RE: Revised Remedial Design
4191 First Street, Pleasanton, California
Fuel Leak Case No.: RO0000361

Revised Remedial Design

Unocal Site 7376
4191 First Street
Pleasanton California
Alameda County Fuel Leak Case No. RO0000361

**Revised Remedial Design
Response to ACEH Comments**

SITE MAP WITH PROPOSED DEEP WELL AND TRENCH LOCATIONS

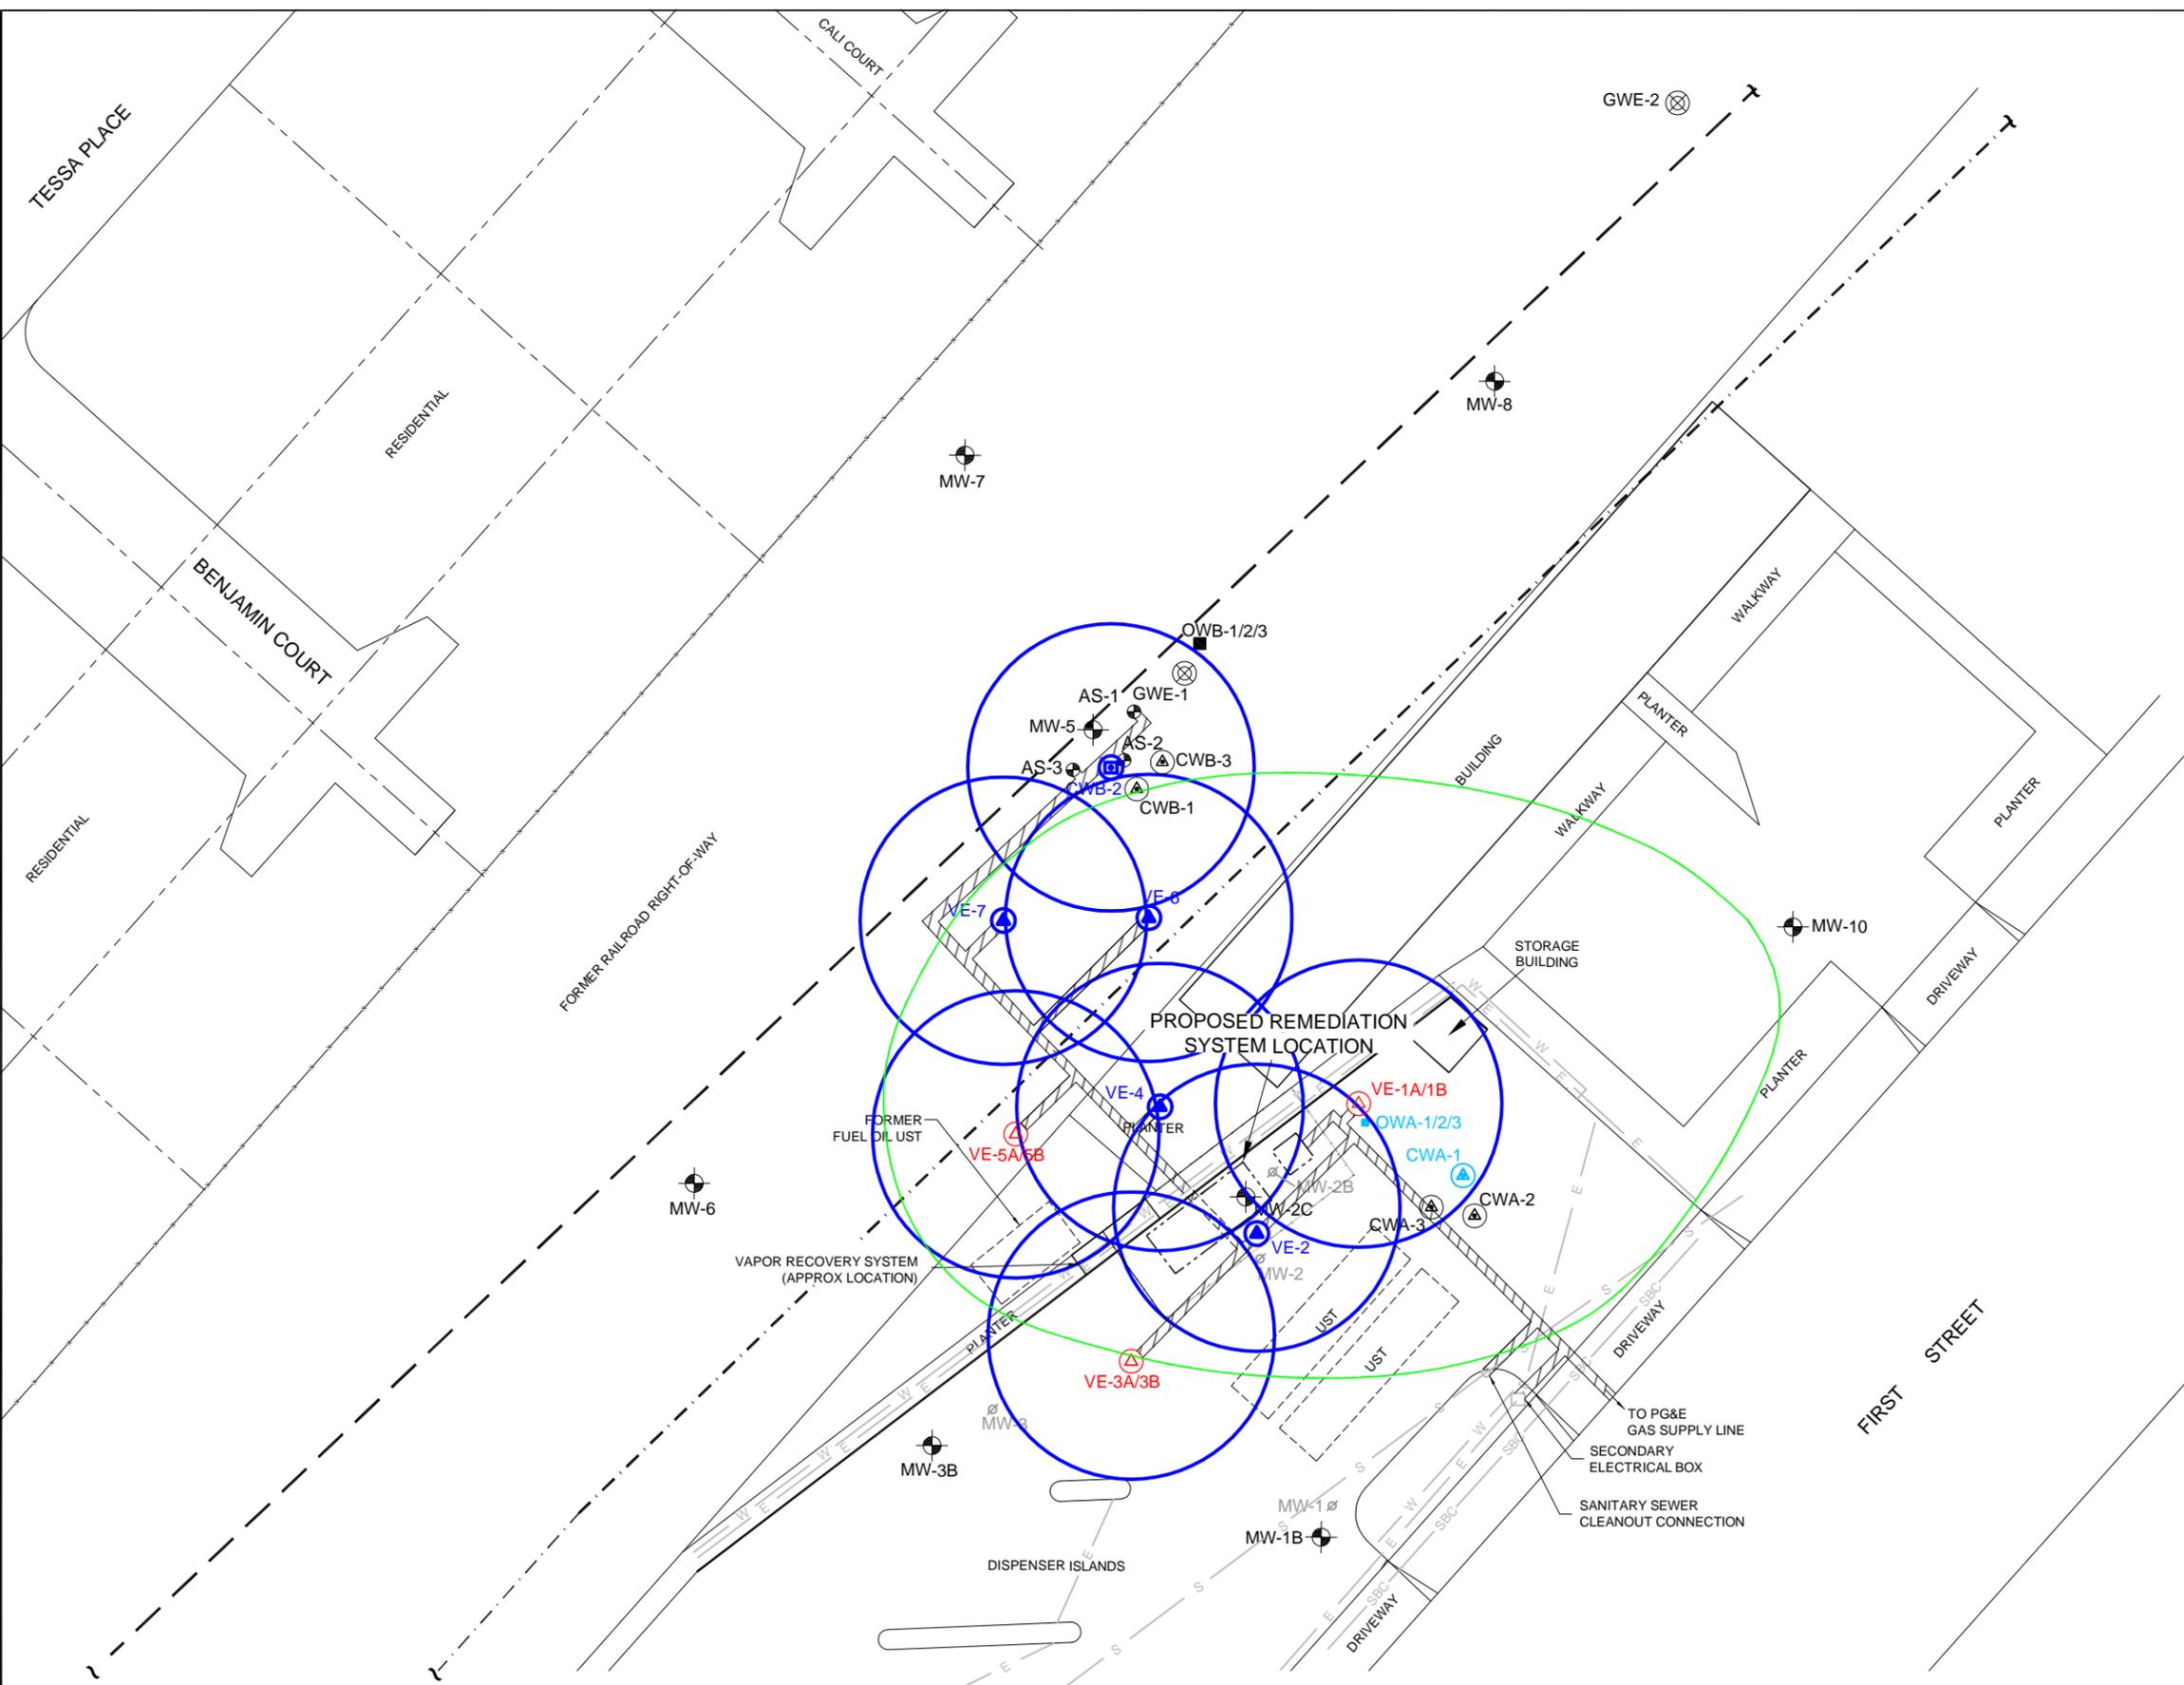
1. ***Radius of Influence and Number of SVE Wells. The Revised Remedial Design indicates that the radius of influence (ROI) was not calculated correctly and proposes the use of higher ROI values for design. As a result, the Revised Design incorporates a significantly reduced number of extraction wells for the soil vapor extraction (SVE) system. Given that the site stratigraphy appears to be complex with possible horizontal and vertical discontinuities, it is not clear that the proposed well design is conservative enough to ensure that the system will be able to adequately treat the targeted area and vertical intervals. We request that you review the site-specific conditions and re-consider the design in light of the site heterogeneity. Upon review, if you believe that the proposed design is adequate, please include a sufficient number of vapor monitoring points in the design to allow assessment of the system performance during SVE operations.***

- 2. *Air Sparging and Removal of Groundwater Extraction. The proposed incorporation of air sparging in lieu of groundwater extraction is acceptable. In the Revised Remedial Design requested below, please include the three proposed air sparging wells into the remedial system. Groundwater extraction may be used as a contingency.***

- 3. Compound Location and Abatement Equipment. In the Revised Remedial Design requested below, please include a new location for the system compound. The size of the abatement equipment may be modified as necessary to match the anticipated treatment volumes.**

Offsite monitoring well CWB-3 will be used to monitor shallow induced vacuum gradients. Offsite monitoring wells CWB-2 and CWB-3 will be used to monitor deep induced vacuum gradients (Figure 1B). In addition, proposed vapor extraction wells VE-4, VE-5B, VE-6, and VE-7 will be used to monitor deep induced vacuum gradients when not in operation.

The three proposed offsite air sparge well (AS-1, AS-2, and AS-3) locations are shown on Figures 1A and 1B. The remediation compound was designed to allow space for contingency groundwater extraction system components. A sewer cleanout connection will be made during trenching activities to allow

The new proposed remediation compound location is shown on Figures 1A and 1B. The new location selection process included evaluation of accessibility, minimal disturbance to service station operations, distance from the nearby office building, and structural stability of existing topographic conditions.
